From: Nigel Martin <nigel@nigelmartin.net>
Sent: 14 July 2010 09:54
To: Keith Morgan
Cc: Irene Dyson
Subject: Re: Adj 1 Mill Hill, Shoreham: ADC/0212/10 for amendment
Attachments: NM A1 template 891.05G Basment Pl.pdf; NM A1 template 891.02 N Gd. Ft. Fl.pdf

----- Original Message -----
From: Keith Morgan
To: Nigel Martin
Sent: Tuesday, July 13, 2010 1:59 PM
Subject: Adj 1 Mill Hill, Shoreham: ADC/0212/10 for amendment

JOB TITLE
PROPOSED HOUSE

LAND AT 1 MILL HILL
SHOREHAM–by– SEA
WEST SUSSEX

GARAGE FLOOR PLAN

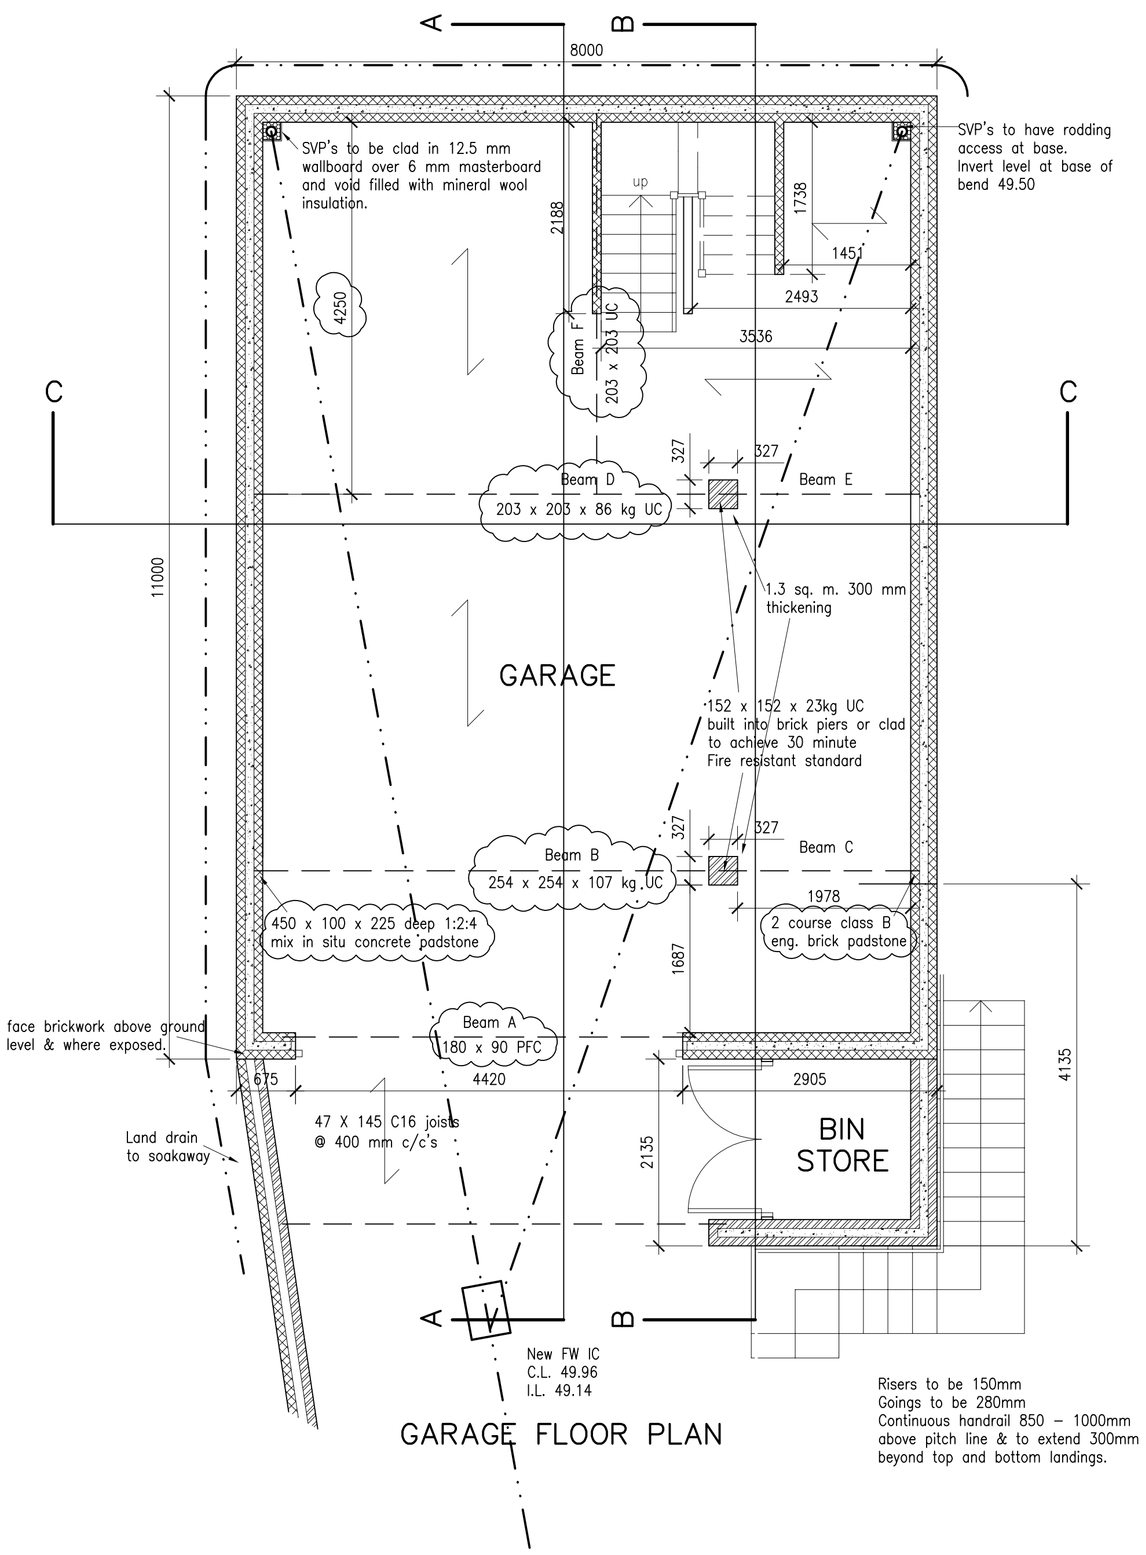
On the Elevations 891.06.03 E the enlarged garage projection/roof terrace is shown projecting no more than 4m overall.
However, on the Floor plan 02 M it is shown projecting further (about 4.6m).

02.08 Section C – C and details added.
B 15.02.08 Fire protection and insulation noted to SVP's.
External steps modofied to comply fully with A. D. Doc. M.
C 18.03.08 Eng's details added.
D 12.08.09 Stairwell dims added to floor plan.
Beam codes over Garage added.
E 21.08.09 Beam dims added.
Padstones noted.
Beam G omitted.
Beam details added.
F 14.06.10 Terrace extended to front of Garage.
G 14.07.10 Extended Garage floor plan dimension revised and noted.

DRAWING NO.	REVISION
891.06.02	N

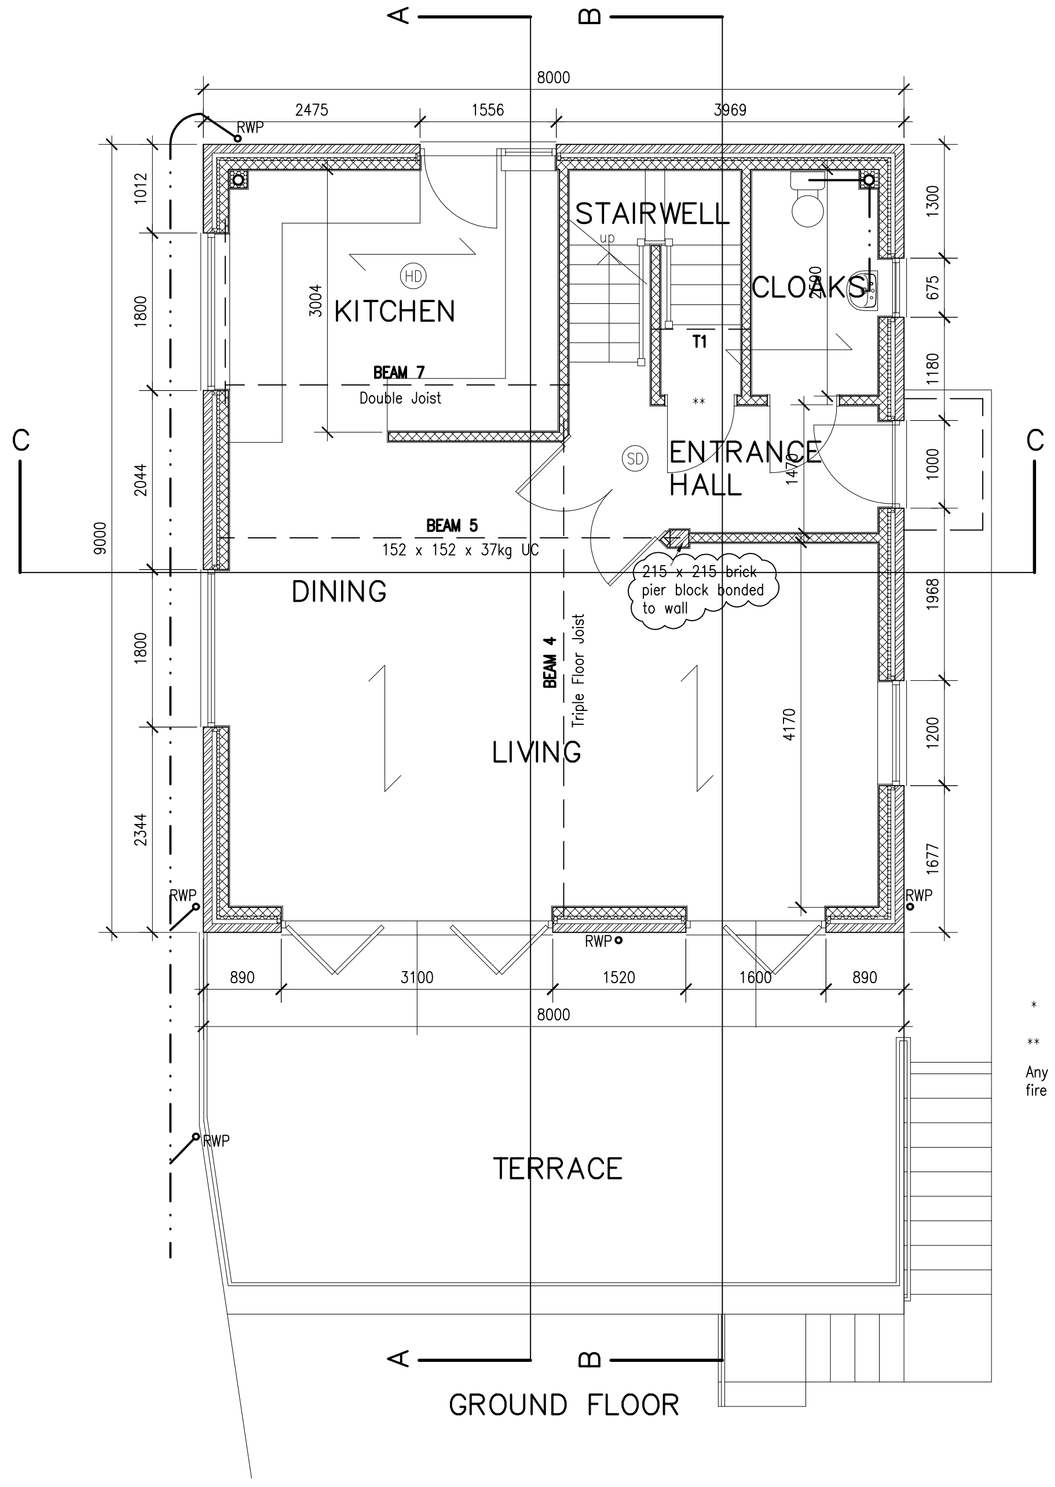
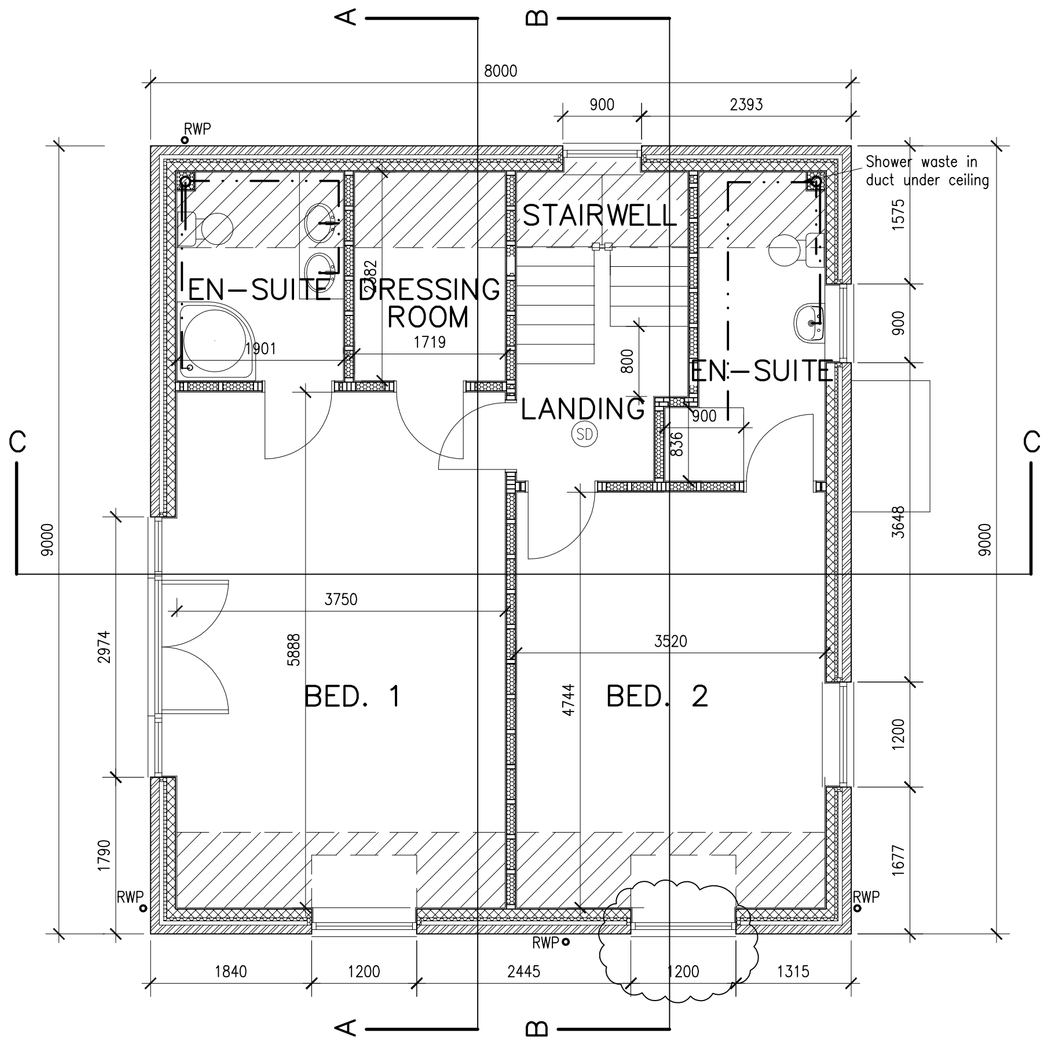
Please can you check. It seems to me that 4m is the maximum that is acceptable.

Having reviewed the relevant elevations and floor plans I have ammended the attached drawings to accord wit the elevations.

M 14.06.10 Terrace to south extended.
N 14.07.10 Ground floor plan terrace balcony line ammended to agree with elevations.
